SLG46880-A Errata Note

This document contains the known errata for SLG46880-A and the recommended workarounds.

Figure 1. Example Data

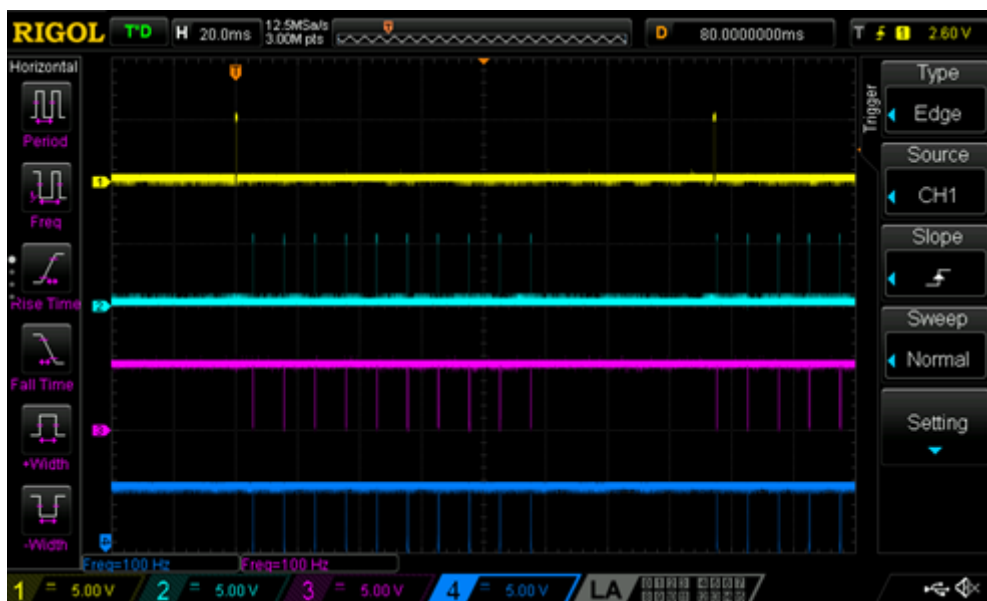
Asynchronous interaction between the CNT/DLY clock input and the I<sup>2</sup>C latch signal (generated by an I<sup>2</sup>C read command of the CNT/DLY block's count value) can result in an incorrect I<sup>2</sup>C data read. The CNT/DLY block will count accurately, but the count value transferred into the block's I<sup>2</sup>C read register might be loaded incompletely if the I<sup>2</sup>C latch signal and the clock input occur at about the same time.

The example data capture below shows ten periodic I<sup>2</sup>C reads of CNT2/DLY2 configured to count down at about 16 clocks per read. The sixth read sample erroneously shows a value greater than that of the fifth. The seventh sample reads as if the previous I<sup>2</sup>C error never occurred - the difference from the fifth sample (176) to the seventh (143) is 33 clocks or 16 clocks + 17 clocks as expected.

If the possibility of incorrect I<sup>2</sup>C data reads can't be accommodated for by external software checks, one can guarantee proper operation by stopping the CNT/DLY block's clock during I<sup>2</sup>C reads through one of the following methods: by disabling the oscillator block, by reconfiguring the CNT/DLY block's clock source, or by gating an external clock using a LUT (Look Up Table) in the signal matrix. After disabling the CNT/DLY block's clock, the count registers can be read without error. Please note that this workaround will add the I<sup>2</sup>C read and processing time to the counter's overall clock period.

The best workaround depends on the resource constraints of the application. If the oscillator block doesn't clock other logic elements within the design, a matrix output can be used to manually power down the oscillators for the I<sup>2</sup>C read. When the CNT/DLY block's clock source is routed internally from the oscillator block, I<sup>2</sup>C commands can temporarily reconfigure the CNT/DLY block's clock source registers to select "Ext. CLK. (From Matrix)." This action will disable the clock by connecting it to ground. If the CNT/DLY block is clocked from the signal matrix, LUT can be used to gate the clock during an I<sup>2</sup>C read.

Figure 2. Testing Design

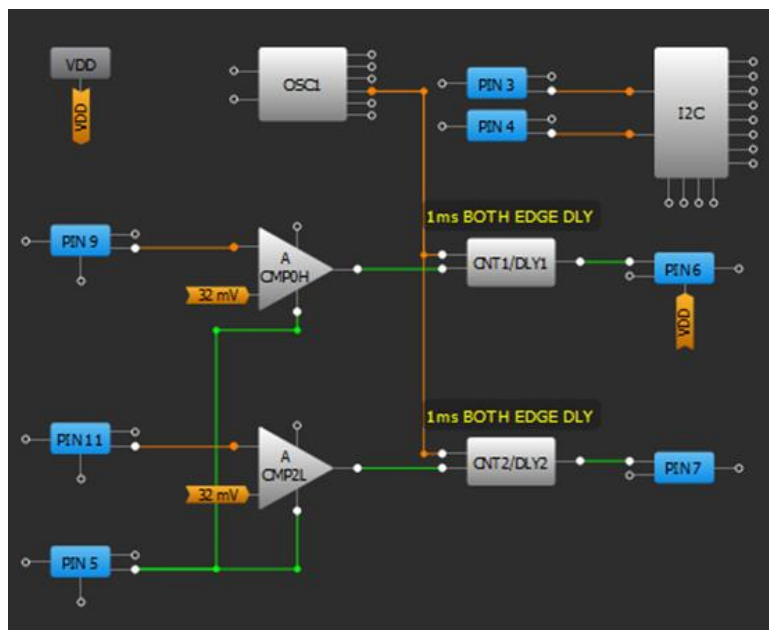
There is some noise coupling from the Vrefs of high-speed ACMPs to the low-power bandgap (BG) while the high-speed ACMPs Vref is turning on and off.

There is no issue with manually powering up the low-speed ACMPs. If you are manually powering up the high-speed ACMPs via the "PWR UP" connector, you should add a 1 ms delay to the output of all of the ACMPs used in the design.

Figure 3. Testing Design

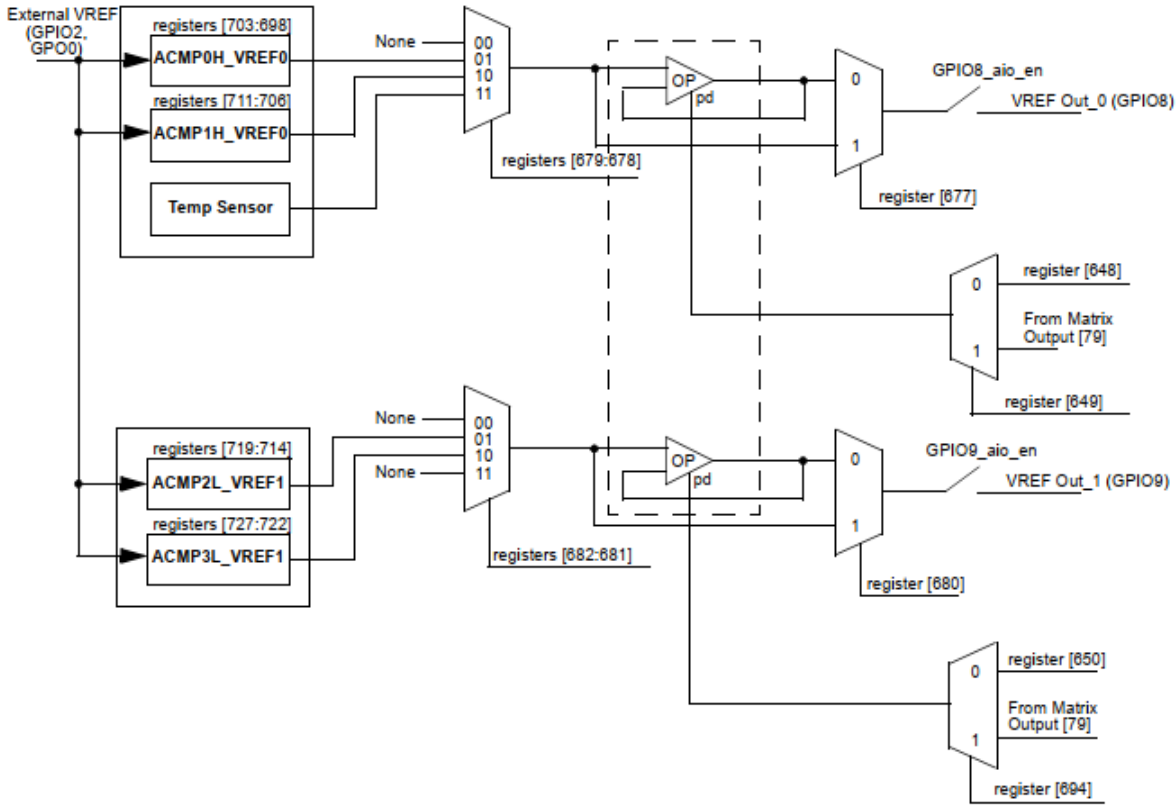
For systems where  $V_{DD} = 2.5\text{ V}$ , the Vref output buffer will be unstable if the output voltage is around  $0.5 \times V_{DD}$ .

For a system where  $V_{DD} = 2.5\text{ V}$ , bypass the buffer if the output voltage of the Vref buffer is within  $(0.5 \times V_{DD}) \pm 0.4$ . Check the Vref section of the device datasheet to see which registers need to be modified.
